REVISIONS		
No.	Remarks	Date
0	Initial submittal	28-JAN-05
0	Re-submittal	09-MAR-05
0	Re-submittal	02-MAY-05
0	Re-submittal	06-MAY-05

ITEM 525.33 BRIDGE RAILING-NETC 2 RAIL
 TOWN OF BOLTON
 COUNTY OF CHITTENDEN
 PROJECT AC IM 089-2(29)
 BRIDGE 51N&S OVER US ROUTE 2

GENERAL CONTRACTOR: F.R. LAFAYETTE, INC.
 DRAWN: C CRAMER
 CHECKED: []
 DATE: 11-31-04
 SCALE: N.T.S.
 HSC REFERENCE NO.: 1479
 SHEET NO.: 3 of 5

1-89 NORTH BOUND SOUTHWEST ELEVATION LOOKING AT FACE OF RAIL FROM C OF ROAD.

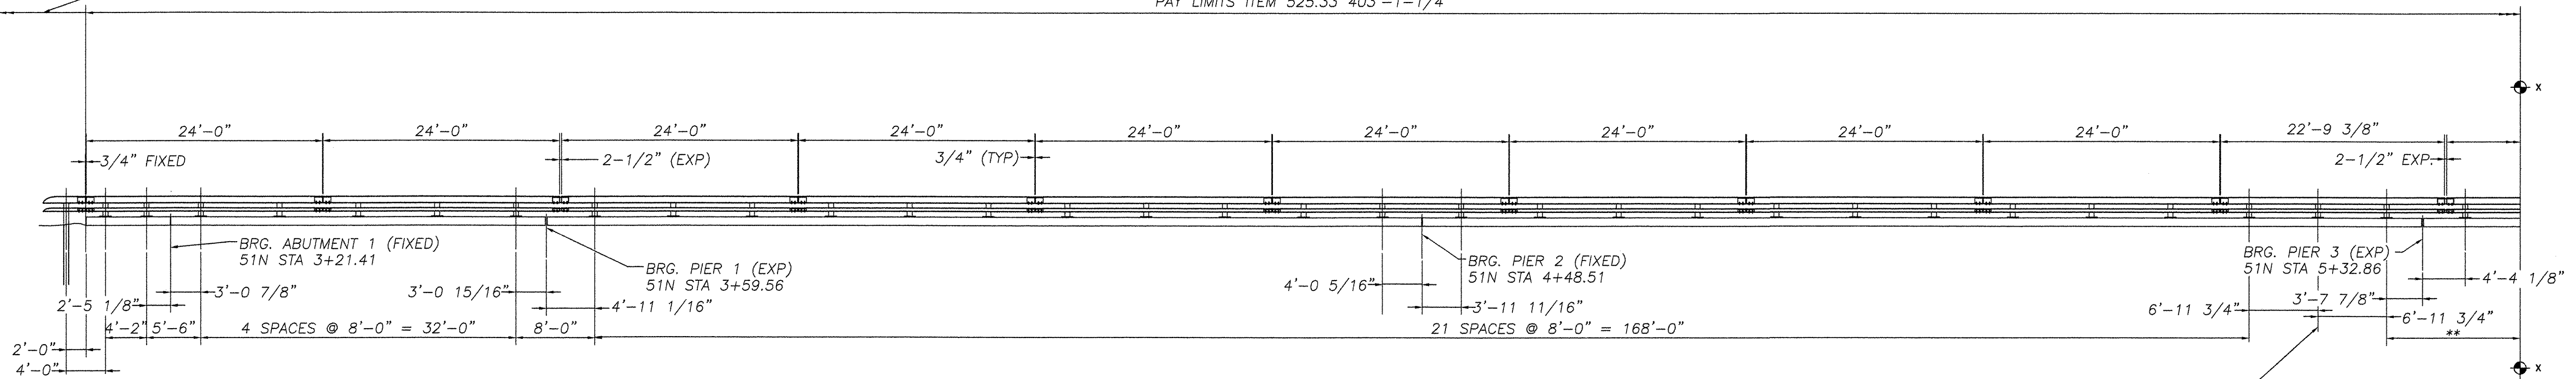
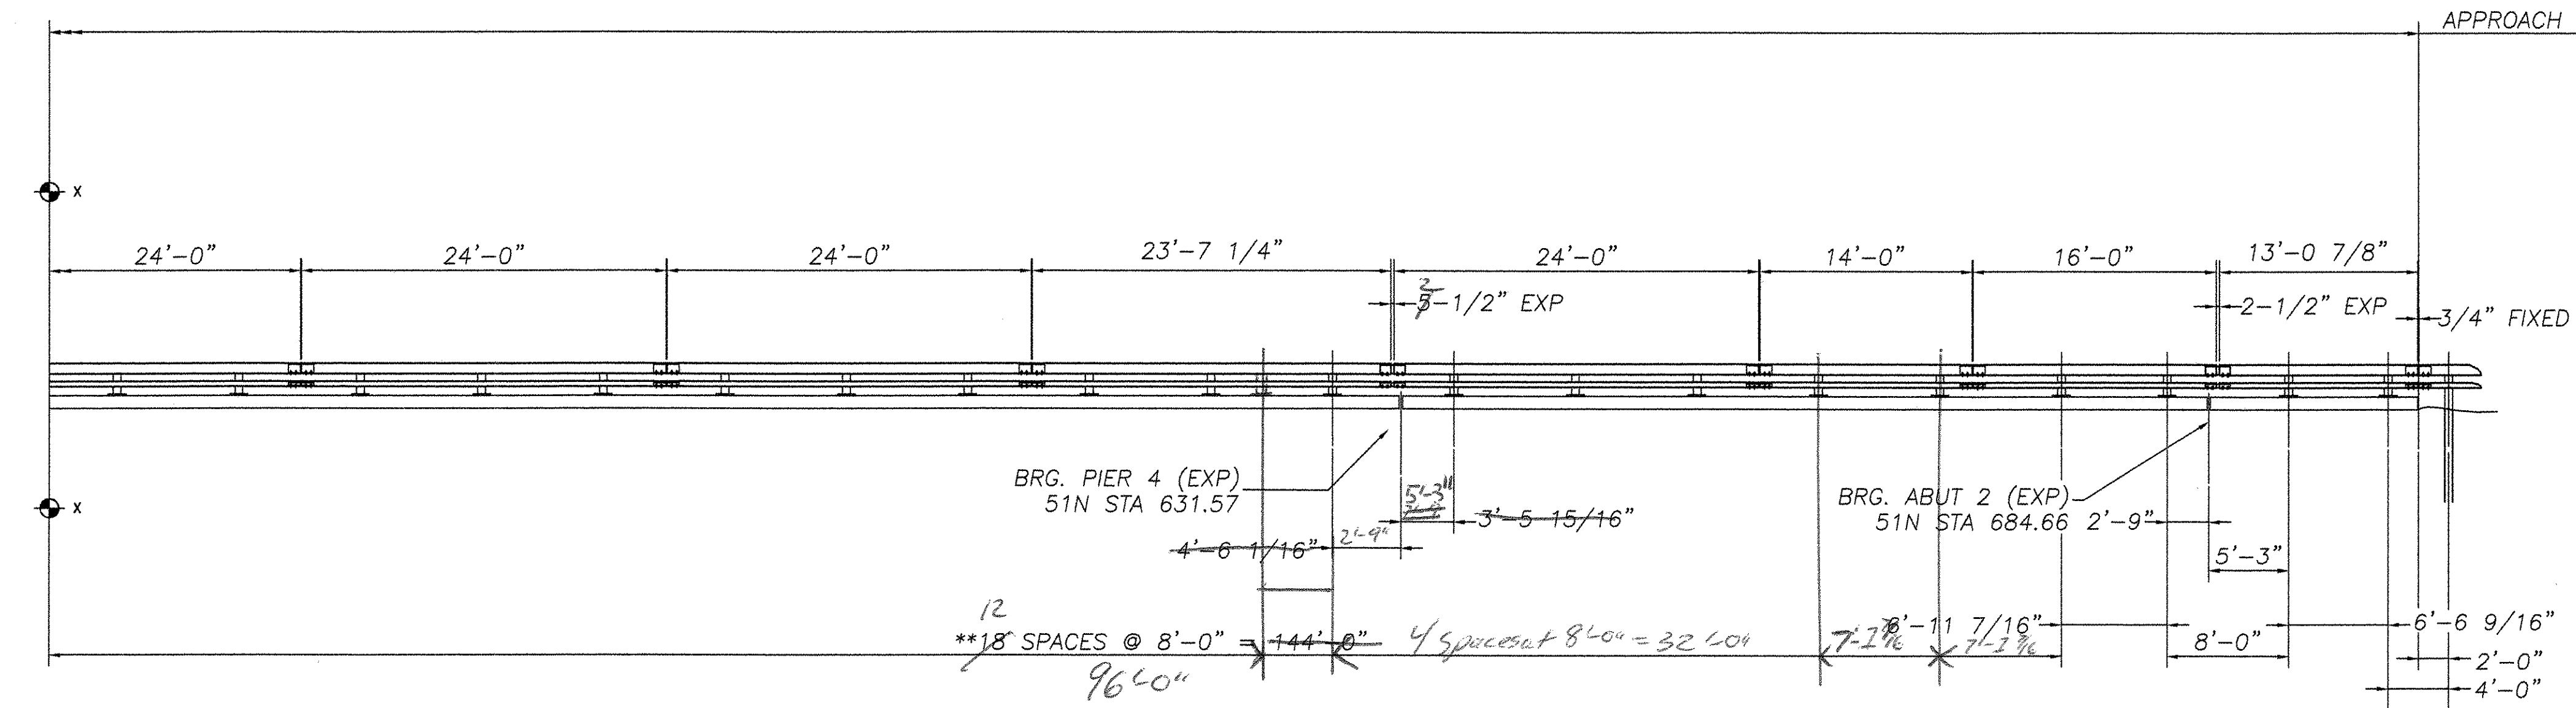
1 ADDITIONAL POST REQUIRED FROM QUANTITY SHOWN IN CONTRACT PLANS TO MAINTAIN 8'-0" MAX POST SPA. AND 2'-9" MIN. SPACING FROM JOINTS

END OF WINGWALLS HAVE BEEN LOCATED APPROXIMATELY BY VAOT SURVEY. CONTRACTOR SHALL VERIFY REQUIRED DIMENSIONS AND RAIL LENGTHS PRIOR TO FABRICATION
